Highway Officer – Response 1

Highway Holding Objection.

After reviewing 20/00476/FUL planning application, the LLFA has found the following:

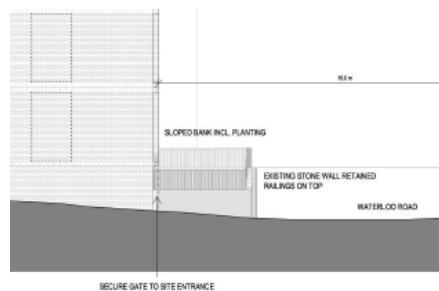
The proposed access to the car park area off Waterloo Road is unsatisfactory in terms of accessibility for vehicles and pedestrians.

However, it is noted that a previous query as to whether this is intended for pedestrian access has not been satisfactorily answered.

Given the Fire Escape egress point, and the secure gate to the communal garden form the parking area (see query below) at the top of the ramp is it is presumed that this is.

The ramp, with a 1:14 gradient, is not compliant for vehicles or pedestrians and there is no footpath or protected walkway for pedestrian/vulnerable users.

The gate detail in terms of effective width of the access opening is not forthcoming and therefore the ability of vehicles to pass on the ramp has not been demonstrated.

Gate detail to understand effective width is also required.
